Land To Rear Of Springbank, High Street, Stoke Golding, Nuneaton LCC Highways Response Tracker

Pell Frischmann (PF) has produced this tracker setting out and itemising the comments from LCC Highways (**Table 1**) to ensure that all the comments are fully reviewed and addressed appropriately.

Description of Application: Demolition of existing dwelling and erection of 19 dwellings, formation of access and associated works

Appendix 2 – 10145-PEF-XX-XX-D-H-000011 P01 Access Road Dimensions
& Visibility

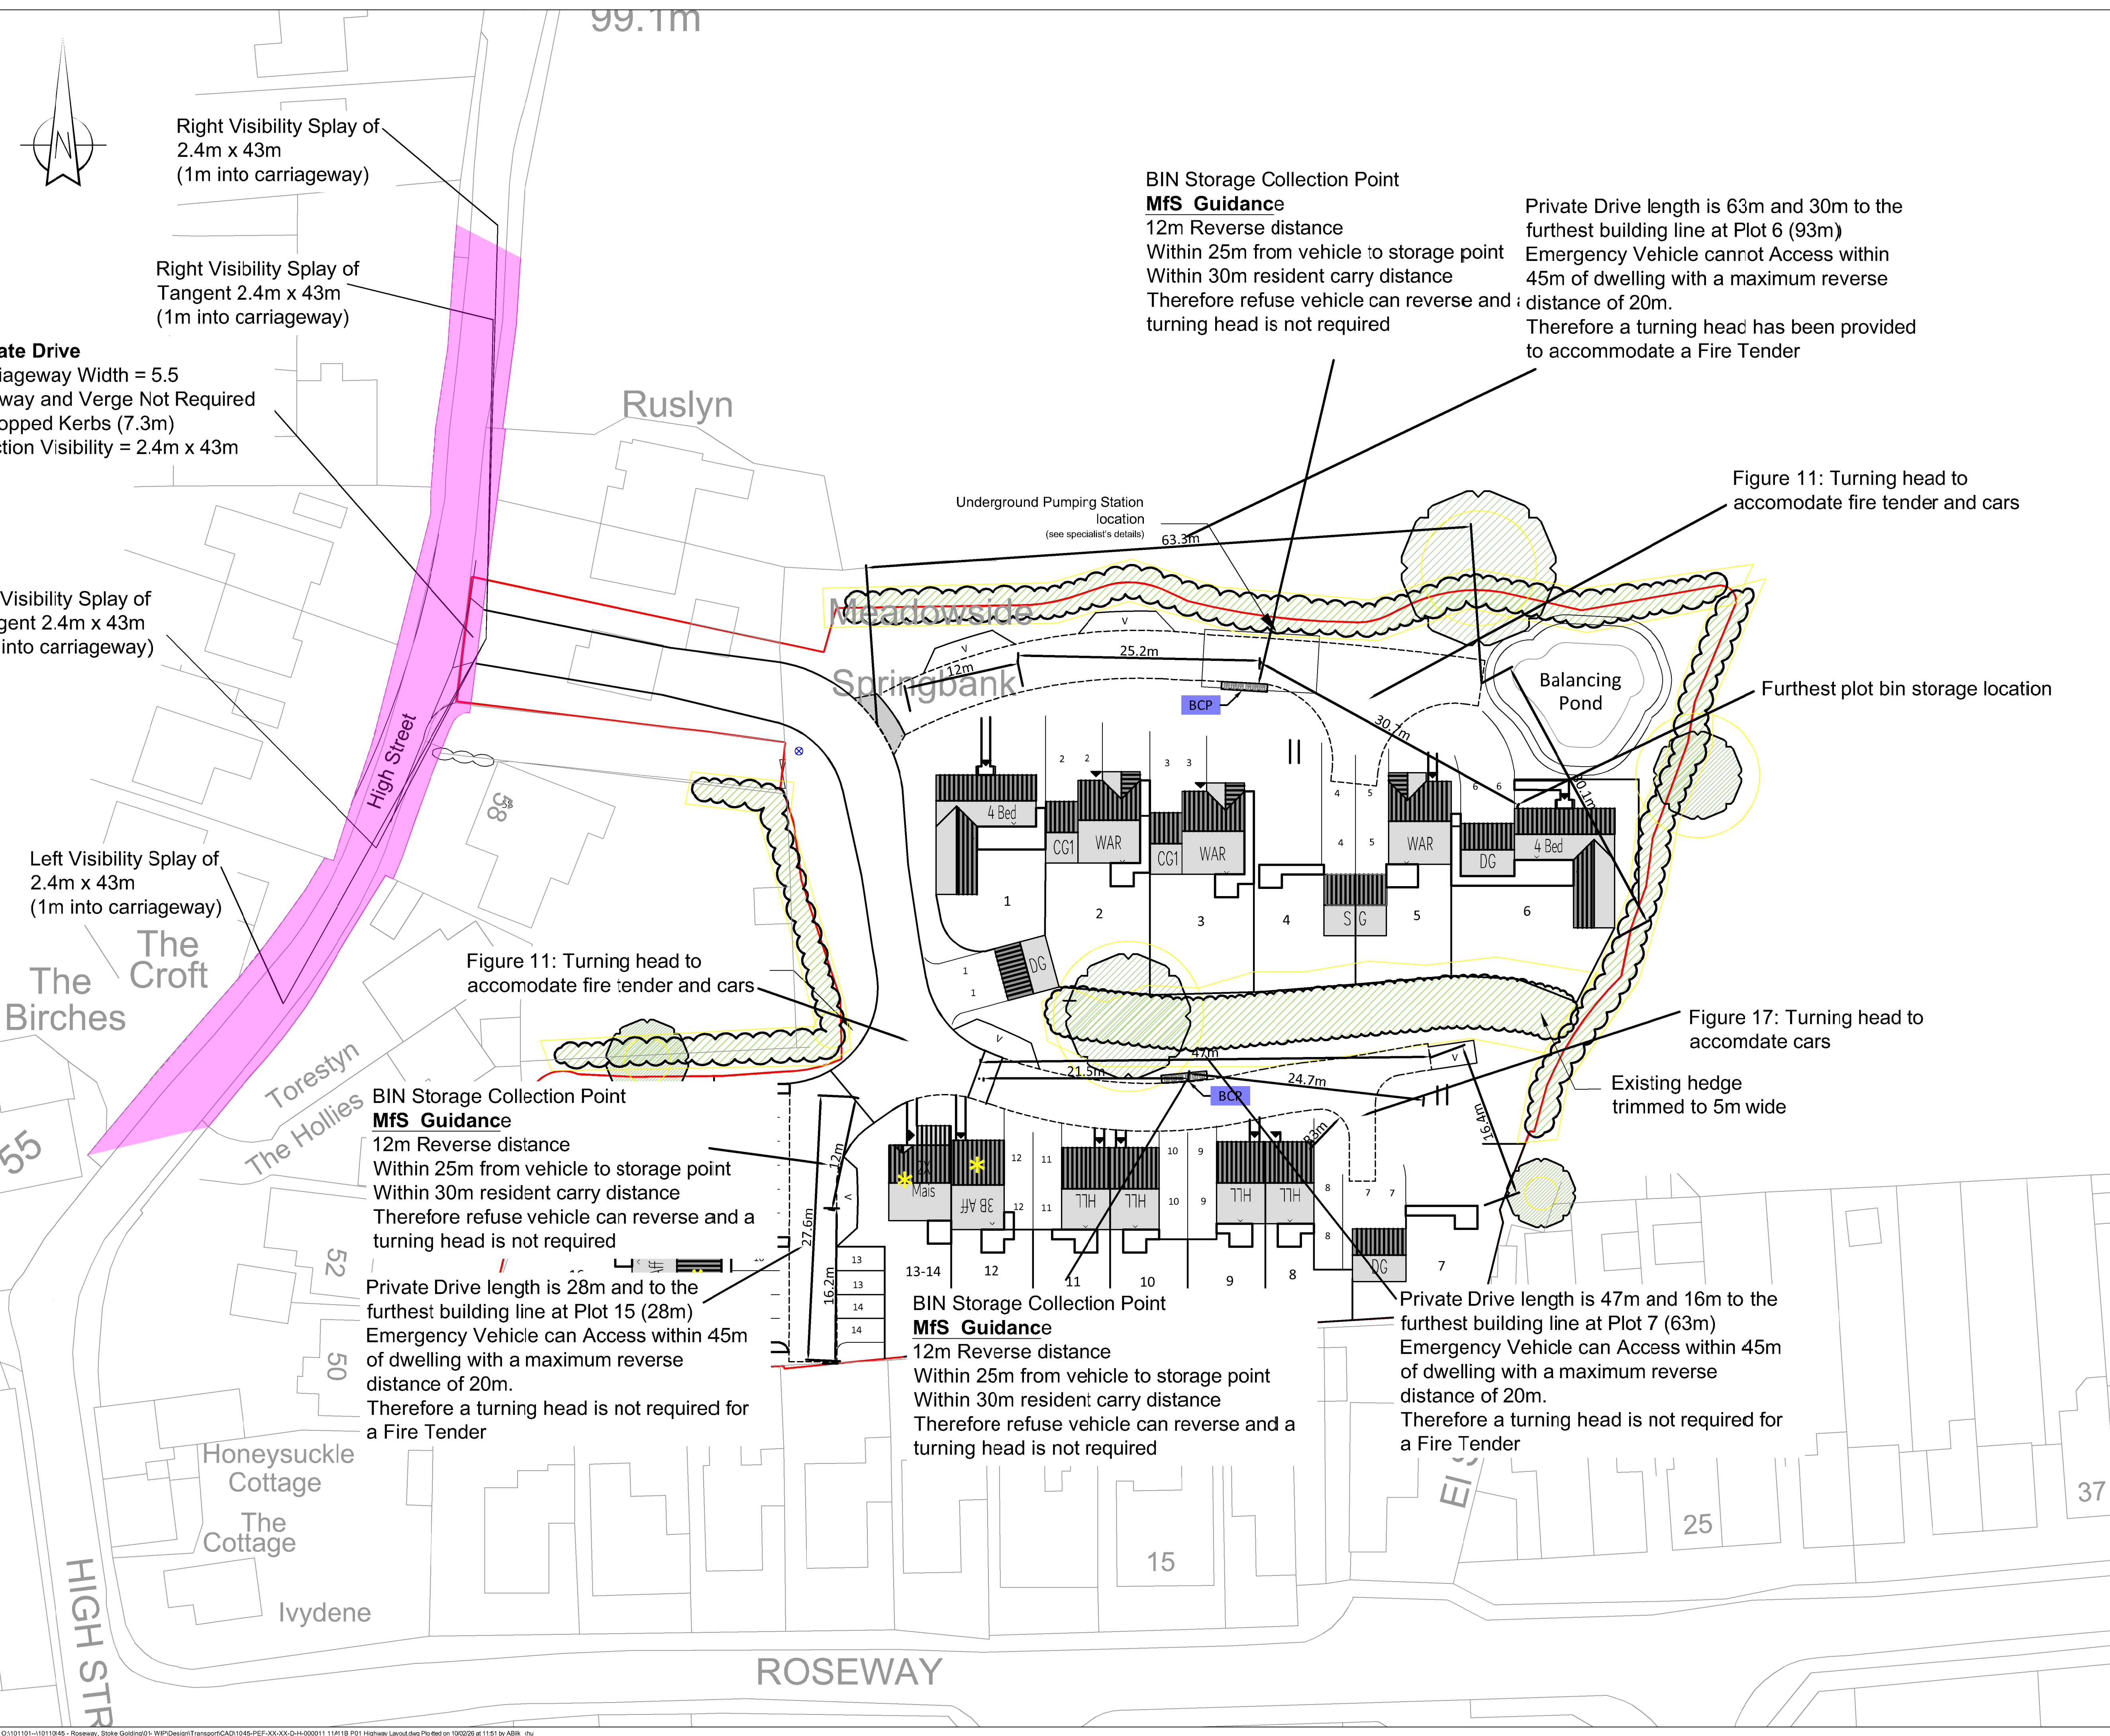
2.	Site Access The site is located on High Street, which is an unclassified, adopted road subject to a 30mph speed limit. The Applicant is proposing to demolish the dwelling called Springbank and create a new access measuring 5.5m wide. This is in accordance with Table 13 of the LHDG whereby a access serving six to 25 dwellings should have a minimum effective width of 4.8m for a minimum distance of 5m behind the highway boundary.	Table 13 also states that: - If the driveway length is more than 25m, its minimum width should be 5m (plus any widening, where bounded by walls) to enable access by refuse vehicles. - Main spine road length is 75m = 5m - Plots 1 to 6 road length is 62m = 5m - Plots 7 to 12 road length is 47m = 5m - Plots 13 to 19 road length is 27m = 5m

3.	The Applicant has demonstrated visibility splays of 2.4m by 43m on the High Street Access Proposed Private Drive/Site Access, drawing number 10145-PEF-ZZ-D-H, Rev P1. The LHA conducted a site visit on 19 November 2025 and recorded visibility splays in excess of 2.4m by 43m in both directions of the proposed site access. This is in accordance with Table 6 of the LHDG.	Junction visibility splays are acceptable.
